February 6, 2019

East Whiteland Township Board of Supervisors
East Whiteland Township Planning Commission.
Municipal Building
209 Conestoga Road
Frazer, PA 19355

Technical Memorandum

Review of Bishop Tube Superfund Site and an Assessment of the Site's Proposed Residential Development

Figure 5: TCE concentrations in 2011 along Little Valley Creek. Source: Roux Associates (2015) Figure 6

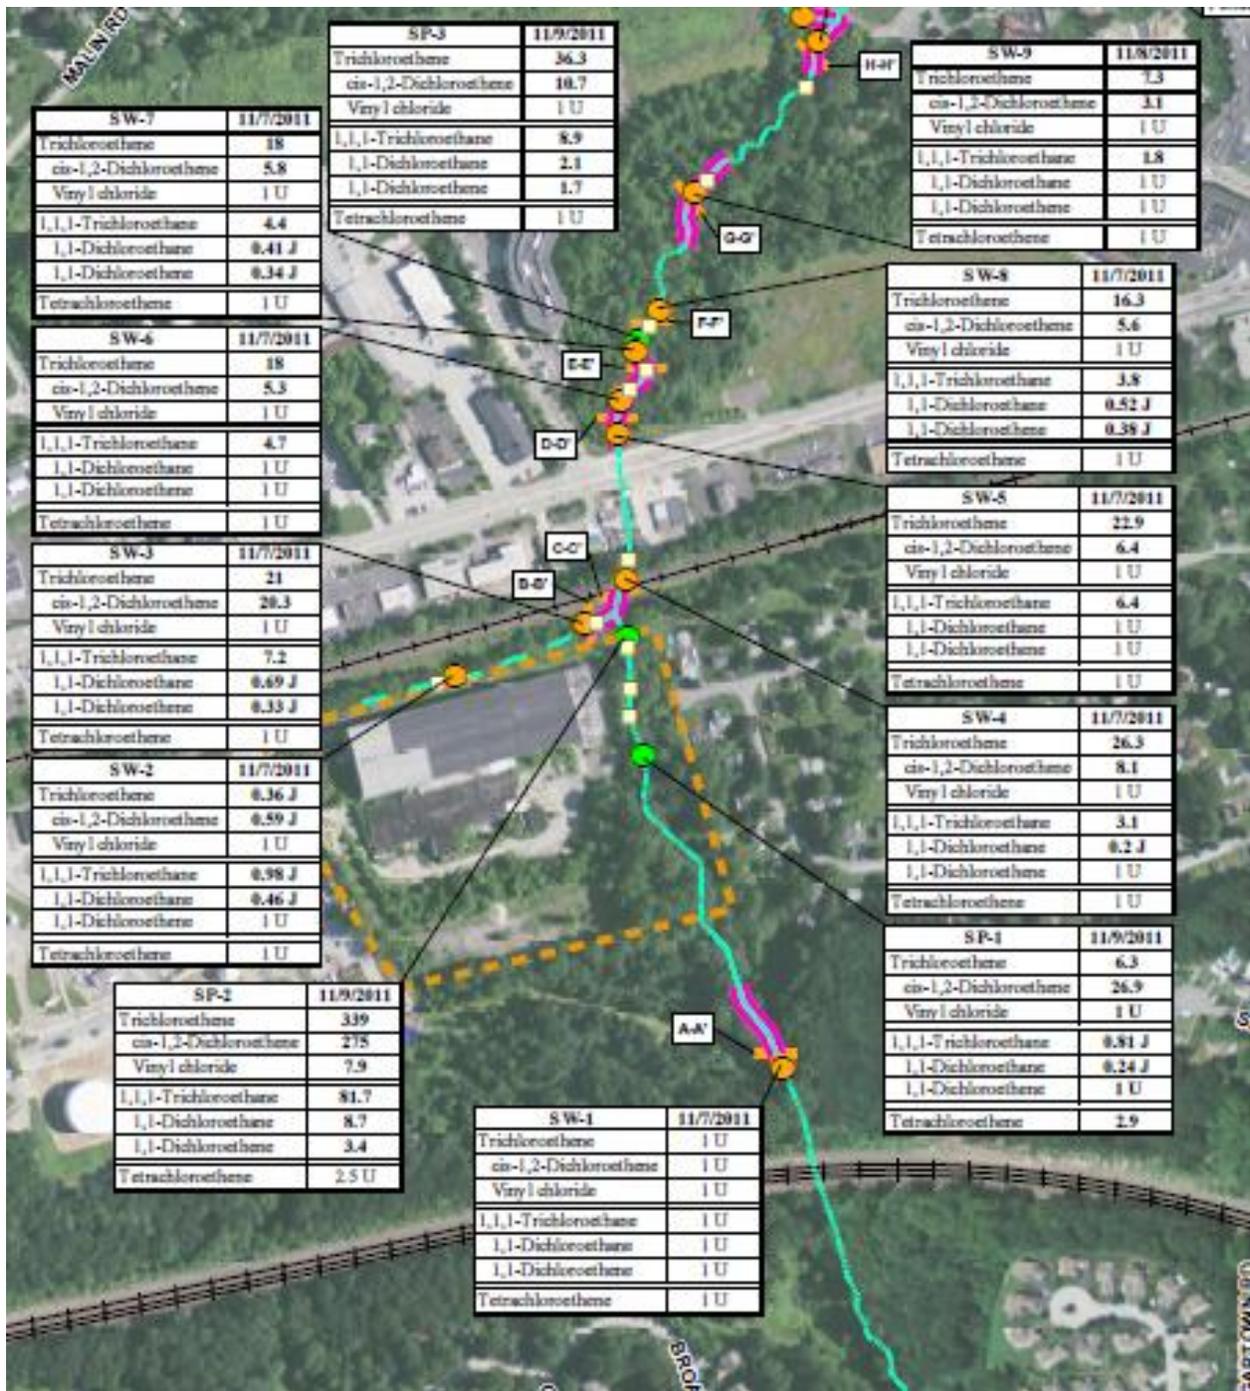
Groundwater discharges to Little Valley Creek on the northeast side of the site (Baker 2009, p 8). TCE-laden groundwater discharges to LVC (Id.), along about a 600-foot stream reach (Baker 2009, p 13). As noted above, the solubility of TCE is low so that as it dissolves it could flow upward toward the streams where there is an upward gradient. The stream TCE concentrations increase where there are springs or where the stream gains flow over fracture zones. Baker (2009) also noted that most TCE contamination was in the bedrock fractures.

Upstream from Bishop Tube, surface water monitoring site SW-1 is essentially non-detect for TCE. Downstream from the site at SW-4, the concentration is about 26 ug/l, which is more than five times the surface water standard. Two springs entering from the site, SP-1 and especially SP-2, have substantial concentrations of TCE (Figure 5). Recent indications are that TCE and PCE have been found at high concentrations at monitoring wells (MW-81 and MW-82a) near 50 Morehall Road¹, which is more than a half mile northeast of the site along Little Valley Creek. Although Roux Associates suggests that there could be a different source, partly by observing that “the relative proportions of PCE are notably elevated on the 50 Morehall Road property”². An alternative explanation is differential attenuation of PCE and TCE or differential transport of PCE and TCE through LVC surface water from Bishop Tube to this site. If Bishop Tube is the source, this is evidence that site contamination is affecting more of the downstream watershed.

Figure 6: Original Preliminary Land Development Plan for Malin Road Development, including 228 townhomes. Source: Sheet 1 of 43, Inland Design (2017)

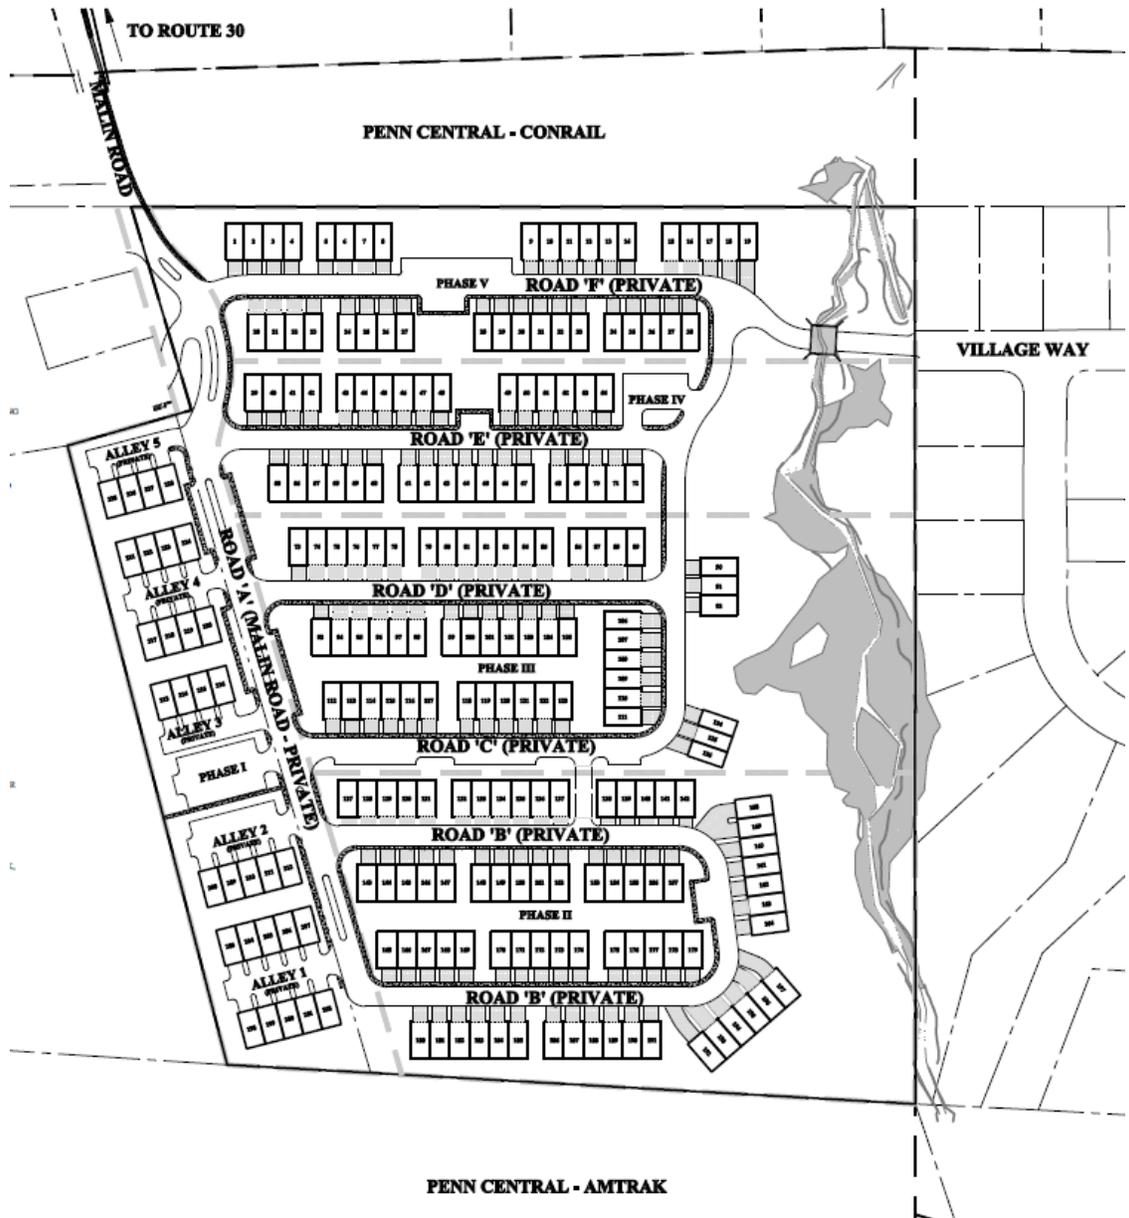
In 2017, Constitution Drive Partners proposed to develop 228 townhome sites for its Malin Road Development (Figure 6). The project has been revised to include 93 units on 13.7 acres (Figure 7). The revised project is approximately the northernmost six rows of the initial plan and covers the same contaminated portions of Bishop Tube as did the original plan. No update of the Environmental Impact Assessment (Smiley 2015) accompanied these revisions. As it stands, the EIA is not useful because it provides little information about the hydrology of the site beyond noting the underlying formations contain a good amount of water and that the stormwater management plan includes infiltration systems to offset the loss of recharge on the site. Smiley (2015) refers to the Bishop Tube industrial site only by claiming the project would be a benefit to the area by removing the contamination and taking down the old building which is a visual issue for the area.

Figure 7: Revised Malin Road Development, including 93 townhomes. The grey areas in north, east and central portion of the site represent contaminated soil. Source: Sheet 4 of 24, Taylor Wiseman and Taylor (2018)

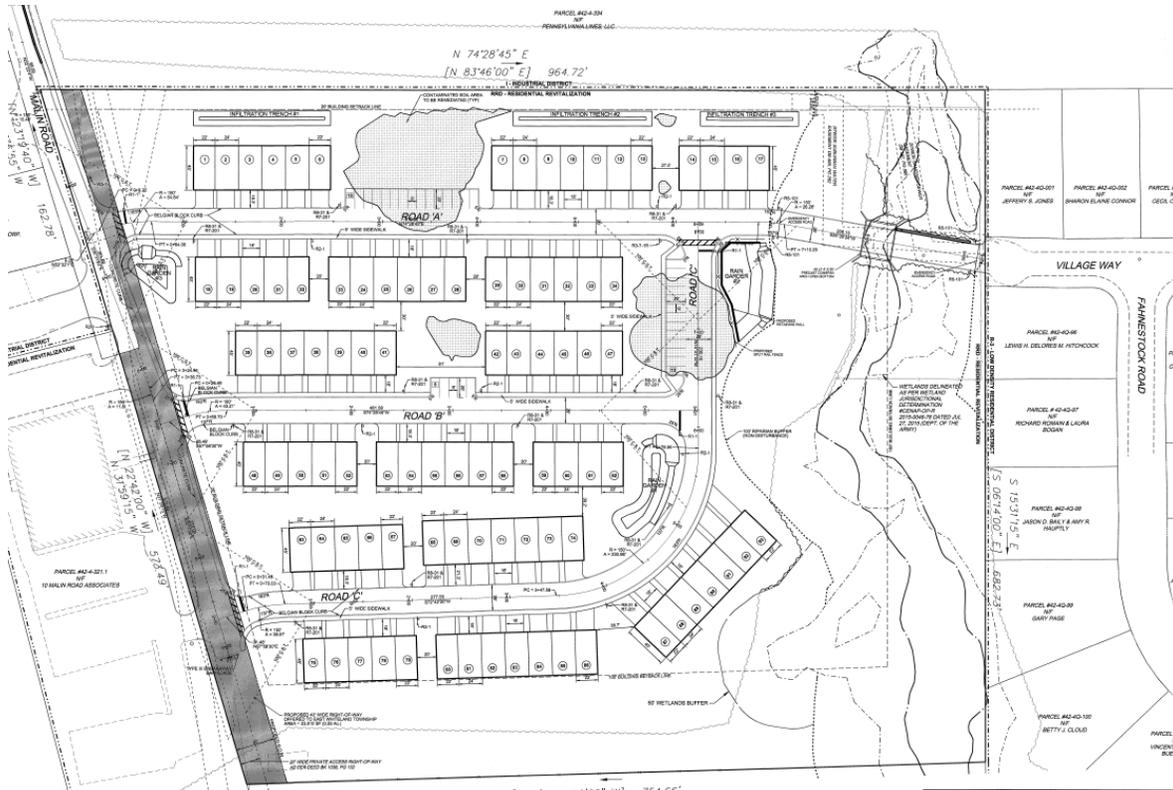
The proposed residential development includes a remediation plan that targets excavation of impacted soils from three discrete areas (Figure 7). Environmental Standards (2017, p 4-4) proposed excavating soils with more than 500 ug/kg of TCE but not deeper than bedrock or saturated conditions. The proposed excavation would include 10,788 tons of soil (Environmental Standards 2017, p 4-2), rather than the 16,511 tons previously proposed (Environmental Standards 2016b, p 4-2). I have not seen any more recent updates based on the revised plan.

As noted above, the site might install infiltration systems to offset the loss of recharge at the site. The revised site plan (Figure 7) shows infiltration systems along the north side of the development. There is no discussion as to the purpose of these infiltration systems. Additionally, removing the existing structure would remove substantial impervious surface from the site, although the development of townhomes and roads/parking area to support them would be impervious. The development would change the distribution of recharge at the site but the question of whether the amount would change is not answerable based on comparison

of the proposed site plan with the existing structure. A substantial increase in recharge could change flow patterns and cause more contaminant to transport to LVC.
